3-6 Spring Place
Spring Place Ltd

Responses to Access
Officer comments
(2018/2592/P)
July 2018

Ground Floor plan

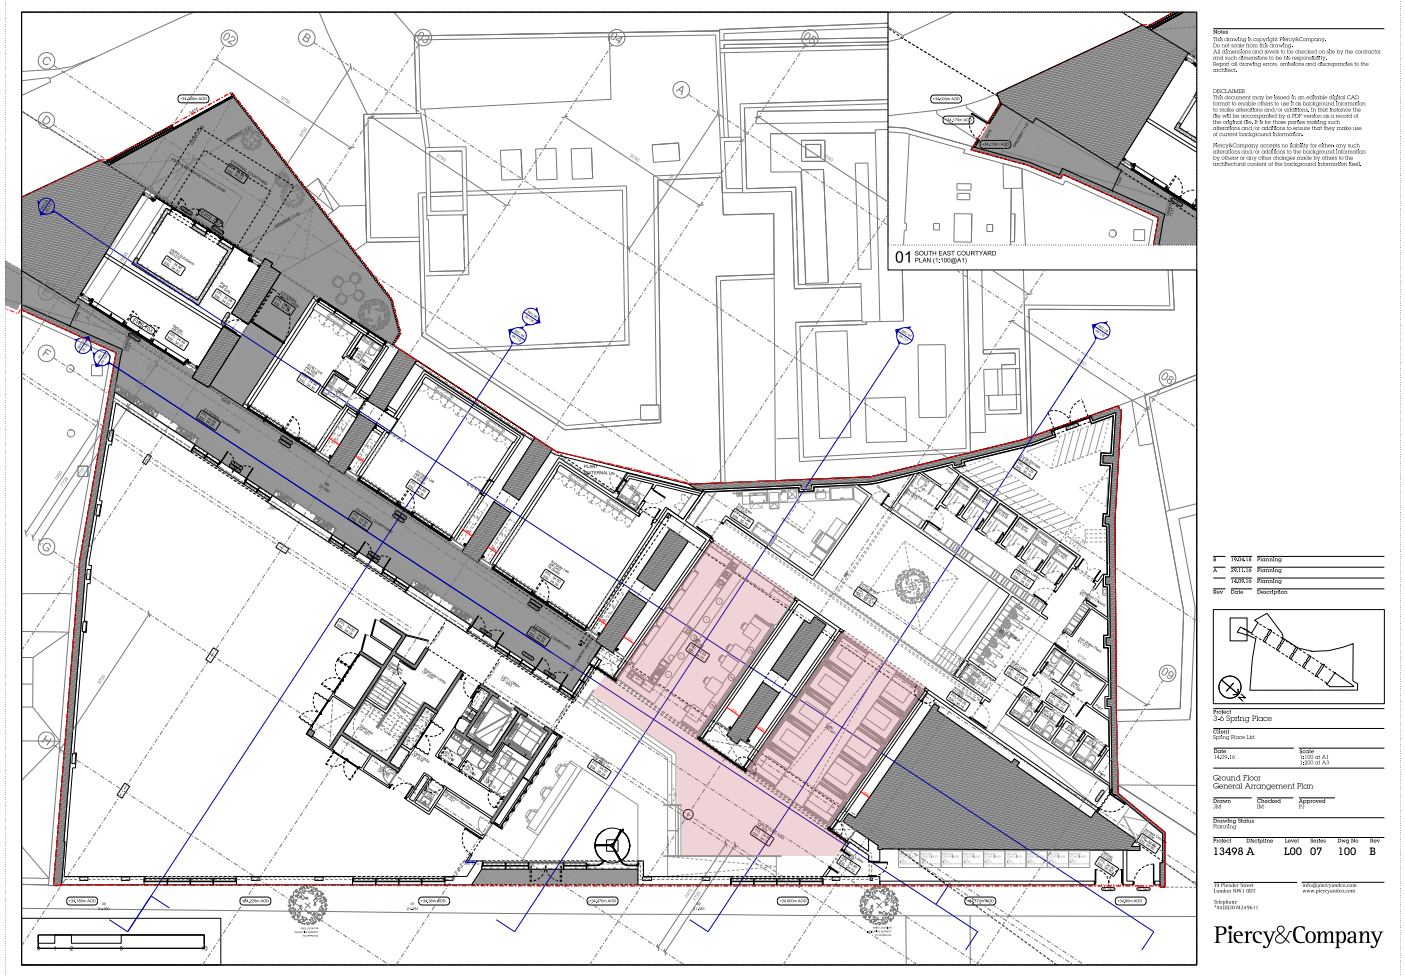
COMMENT 01: At least a proportion of the restaurant seating should be accessible. The large amount of booth seating renders a lot of the seating inaccessible to many disabled people.

The restaurant space is designed to spill onto the identified reception area, which will provide more standard seating, which is accessible. The plan identifies these areas and the indicative layout of the plan shows accessible tables in this space.

Accessible shower layout (plan extract)

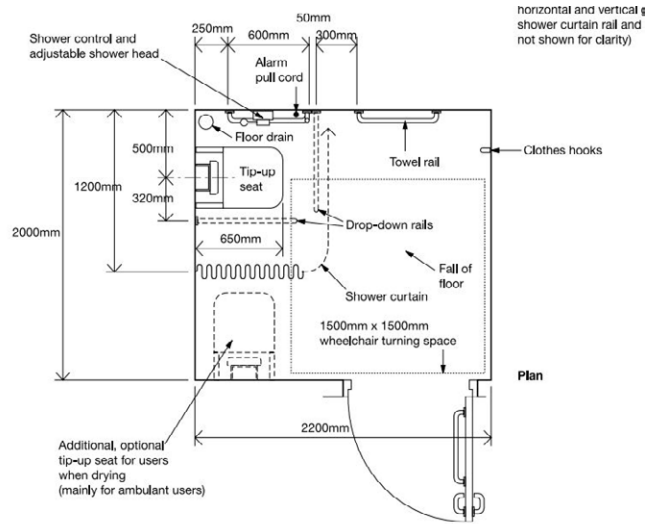
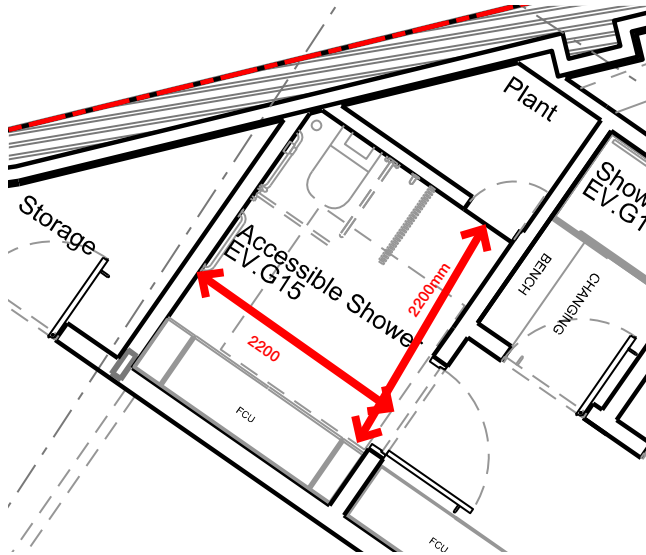
COMMENT 02: The accessible shower should accord with Diagram 23 of AD M.

We can confirm that the accessible shower layout is as per Diagram 23 of AD M. (Albeit the scheme provides a slightly larger configuration).

Cycle Storage (plan extract)

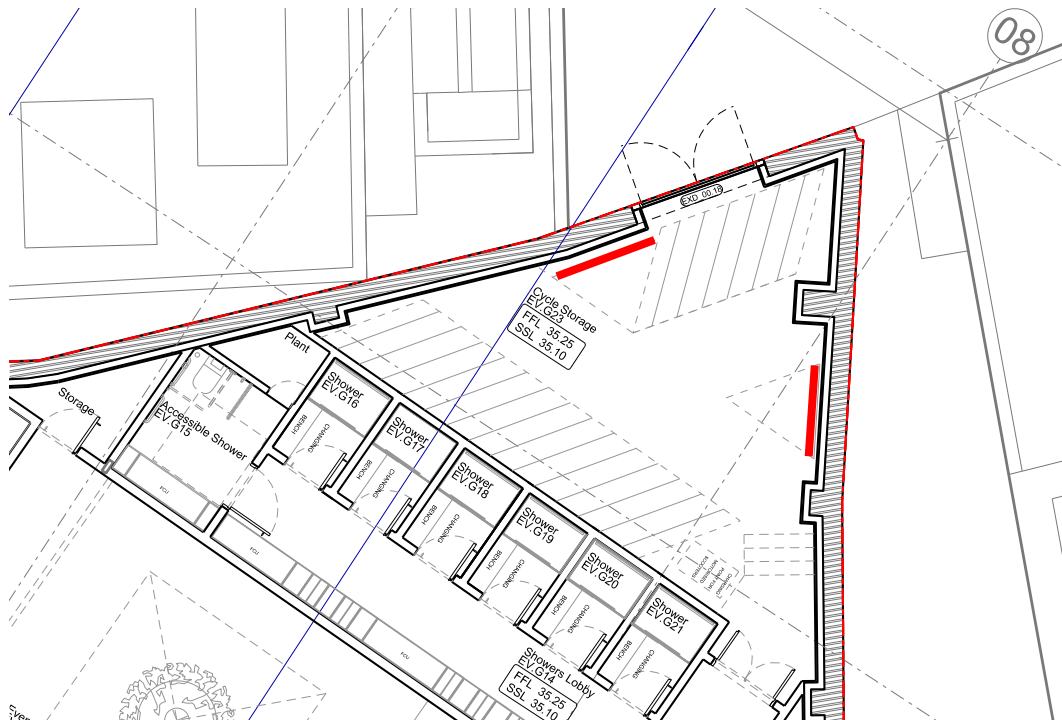
COMMENT 03: Consideration should be given to accessible bike storage for those with non-two-wheel cycles.

There are two Sheffield stands located in the basement cycle parking area as indicated in drawing 13498-A-L00-07-100 (extract below) which are capable of accommodating alternative cycle configurations, including those with more than two wheels. Signage on these stands will confirm that they are for use by non-standard cycles to ensure they are generally available when needed.

The wider cycle parking offer is generous and it is therefore not envisaged that "two wheel users" will need the sheffield stands proposed.

Indicative event layout

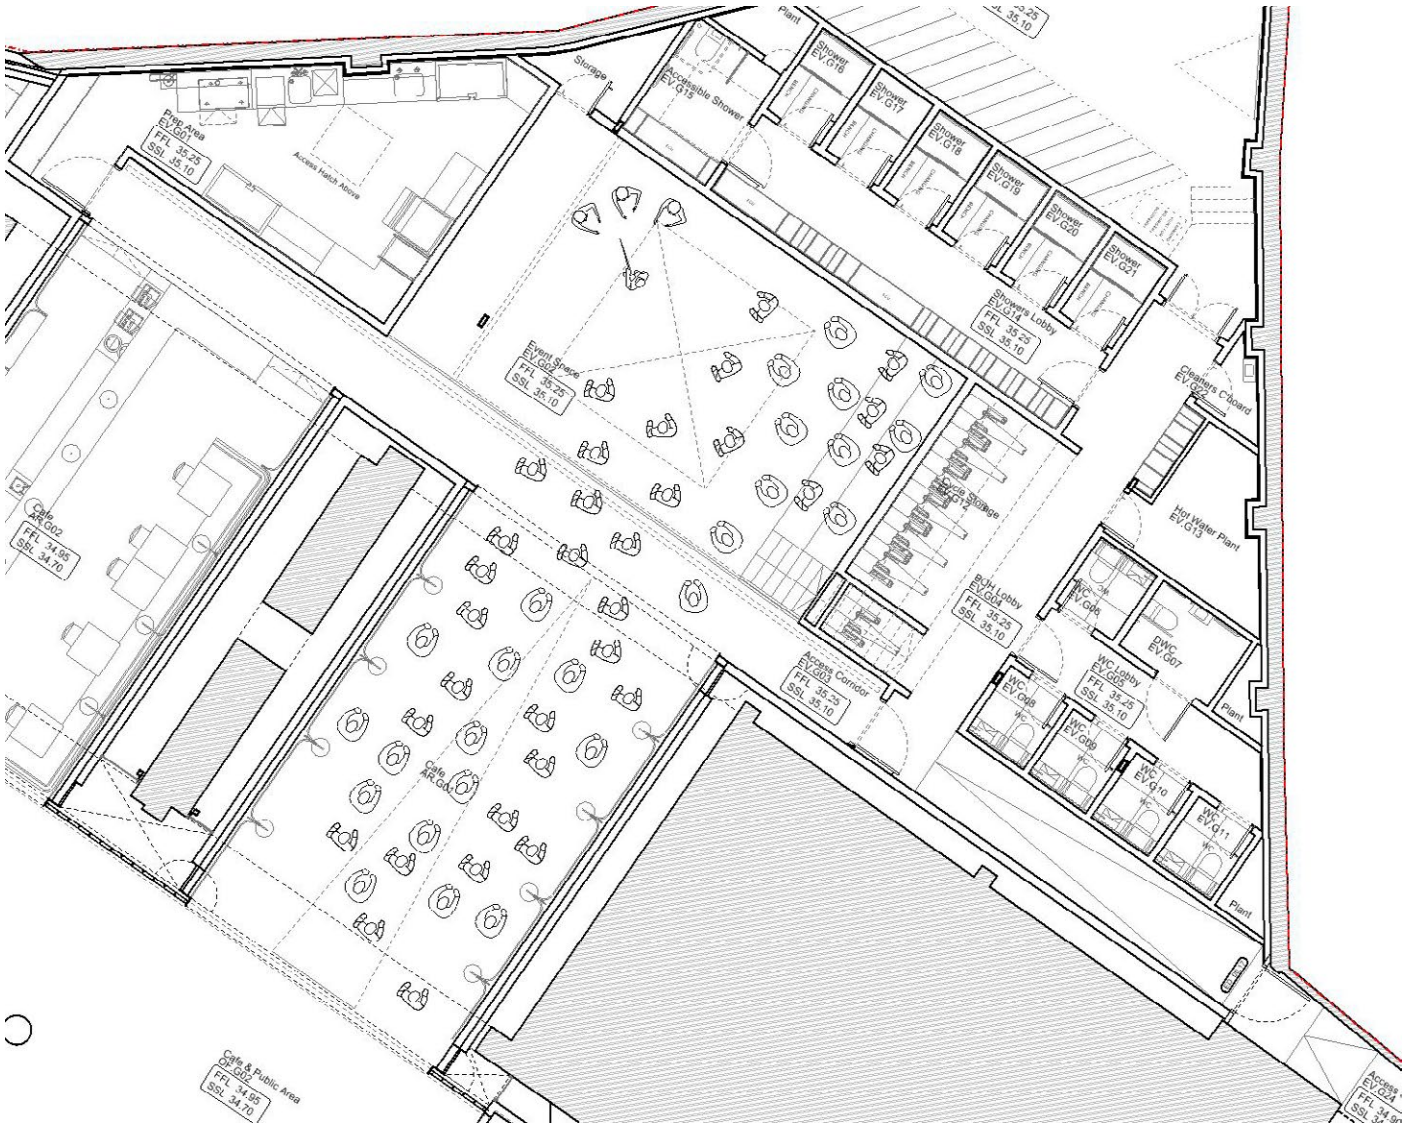
COMMENT 04: It is concerning that the amount of accessible event space is greatly diminished. The mezzanine level where the majority of the event space is has no step free access; this has not been justified in the DAS. The stairs to the mezzanine level should meet with AD K and AD M in terms of hands and step nosings.

As it is the case throughout the building the area where the restaurant booths are designed to be flexible and as shown, the booths will be removable to provide a larger event space area. Larger events will spill onto the cafe and restaurant area.

We can confirm that the stairs have been designed to meet the regulations.
